STAFF REPORT 9-11-2013 MEETING
APPLICATION NUMBER: 13-179
ADDRESS: 7840 VAN DYKE
APPLICANT: CALVIN GARFIELD
HISTORIC DISTRICT: WEST VILLAGE

PREPARED BY: J.ROSS

Description of Proposed Alterations.
South Elevation

RE: Application Number 13-179 (REVISION to Scope of Work Approved in Application Number 12-93); 7840 Van Dyke, West Village Historic District

Dentils at main roof, measure 4 by 6 inches

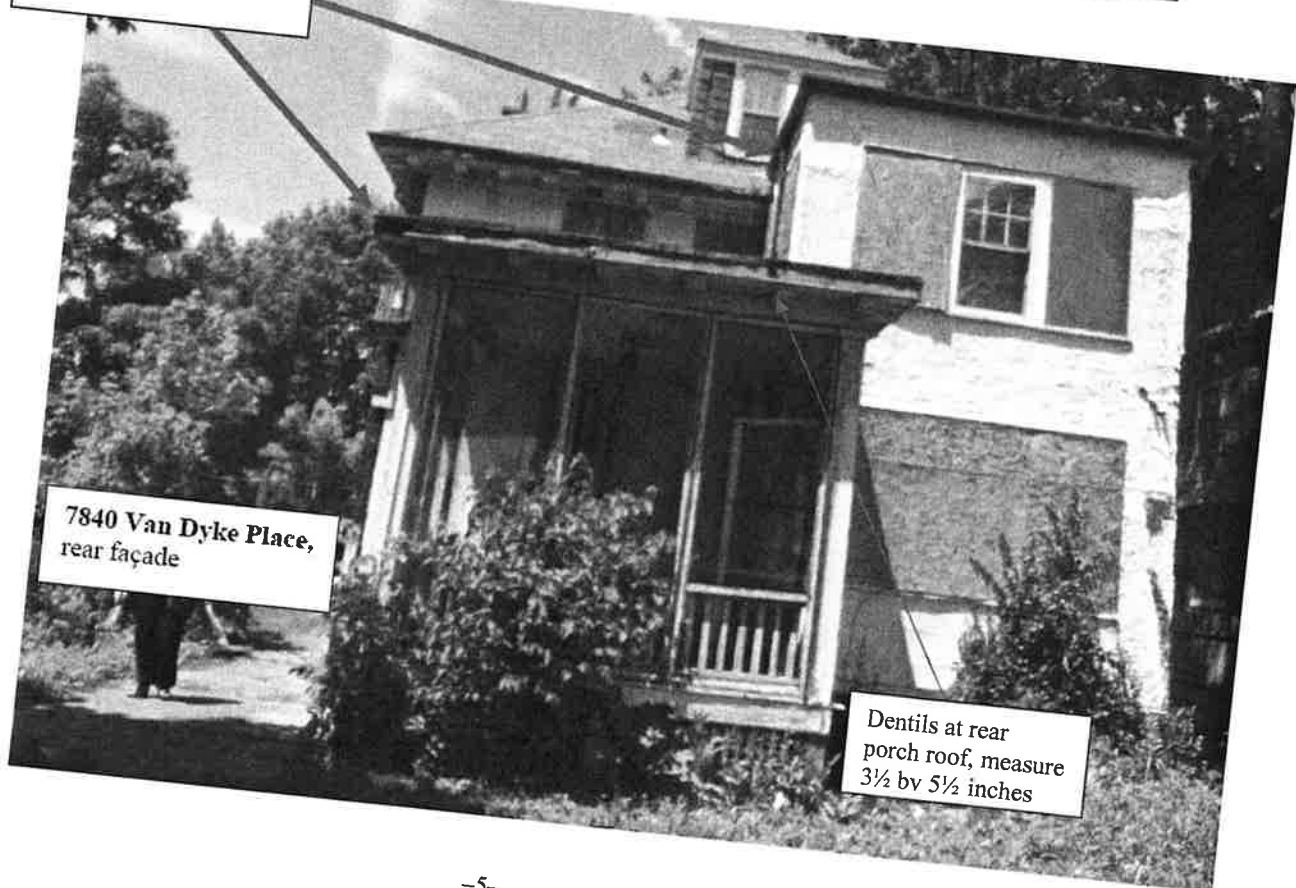
- introduce the eaves detail found on all four elevations of the house to rear two-story wing with two modifications:
 - provide dentals that are sized similarly to those existing at rear porch which are 3½ by 5½ inches rather than those found on the main portion of the house which are 4 by 6 inches as the drip edge of the wing is higher than the remainder of the house;

Photos submitted by applicant, showing current conditions at rear facade

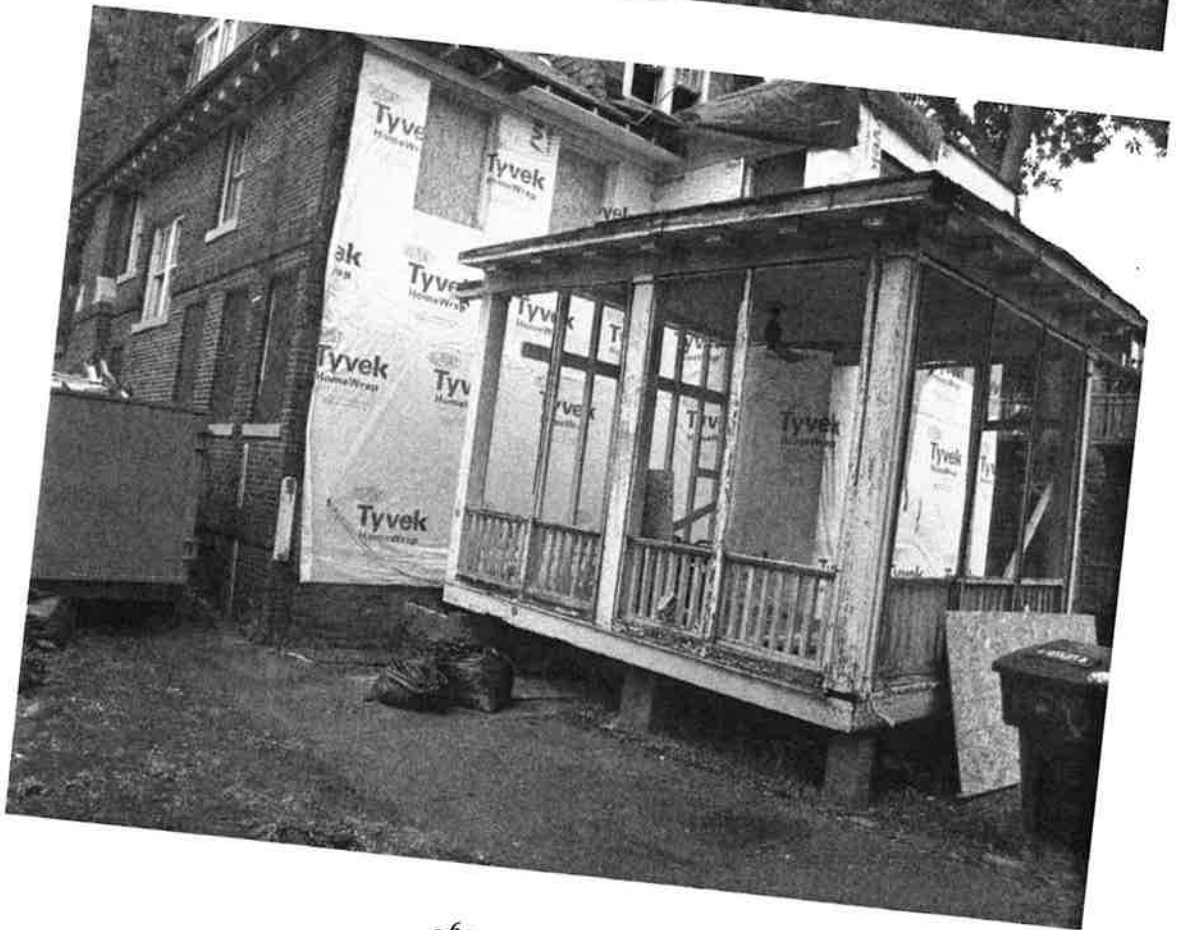
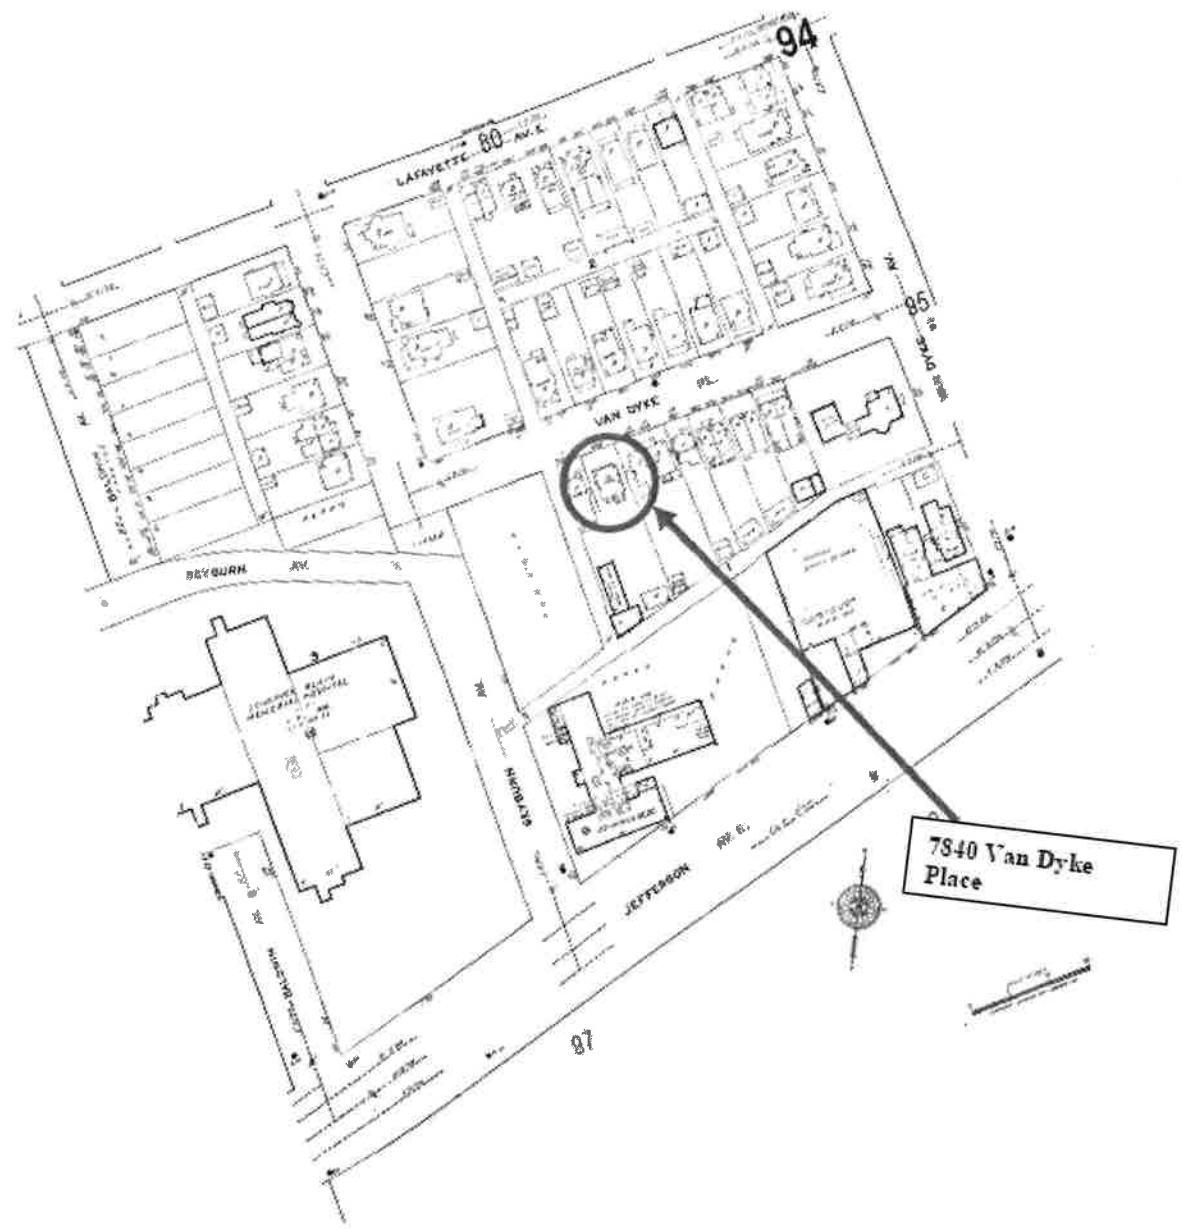
The existing stucco exterior cladding found at the building's rear façade is not a character-defining feature as it is not an element/detail that is indicative of the Georgian Revival style. Furthermore, the brick veneer and new decorative elements proposed for the building's rear façade is compatible to the building's existing stylistic detailing and the new modillions/dentils proposed for the rear two-story wing will be smaller than those existing at the front and side facades' eaves. HDC staff therefore recommends that the Commission issue a COA for the following items because they meet the Secretary of the Interior's Standards, standard number 9) *New additions, exterior alterations, or related new construction shall not destroy historic materials that characterize the property. The new work shall be differentiated from the old and shall be compatible with the massing, size, scale, and architectural features to protect the historic integrity of the property and its environment.*

- retain the existing two-story wing at the rear of the house
- replace the cement plaster/stucco finish at the rear/south façade with veneer brick to match the other three elevations of the house

- install new limestone sills at all windows at the rear façade to match front and side facades
- extend the original masonry details including the horizontal beltlines found on the west, north and east elevations to the south elevation

- repair the and expand the existing rear porch westward approximately 2'-0" in order to fully shelter the rear façade doorway
